2014 Rule C	hange	Decisions
Posted by Sterling D	oc - 12 Nov	2013 18:15

944-SPEC - 944SPEC - low cost wheel to wheel racing

13. Allow use of Lexan for rear side windows.

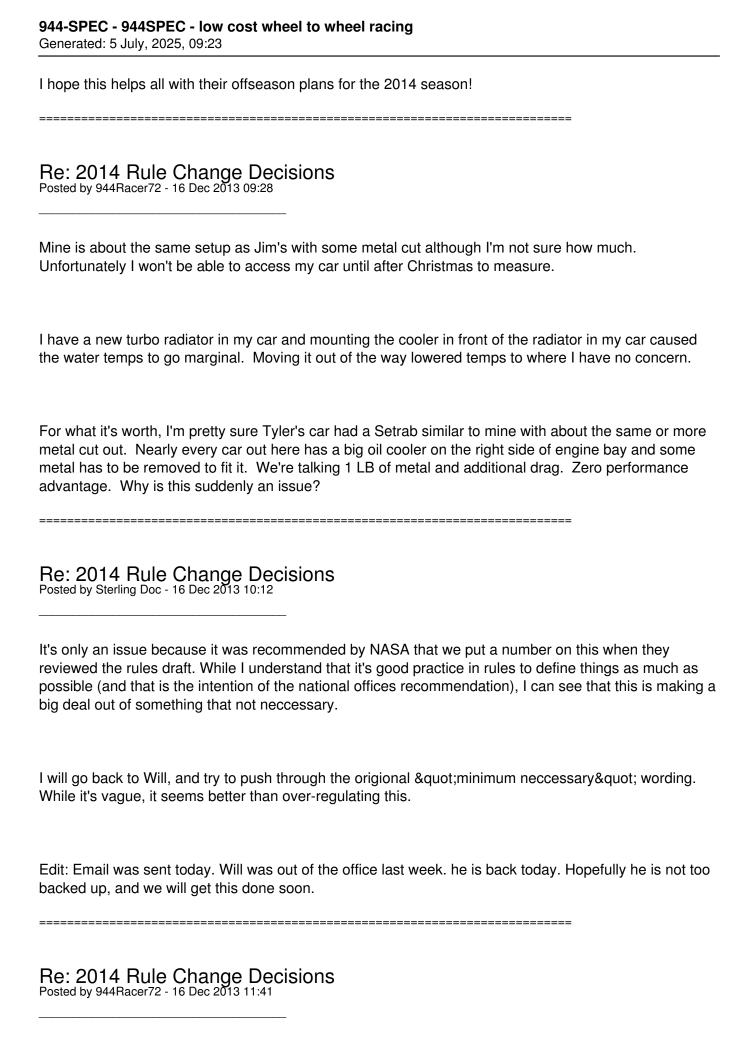
No change in temperature specifications. Series directors will need to be prepared need to use external means to determine oil temps on cars without gauges that read in numbers (or no oil temp gauge at all).
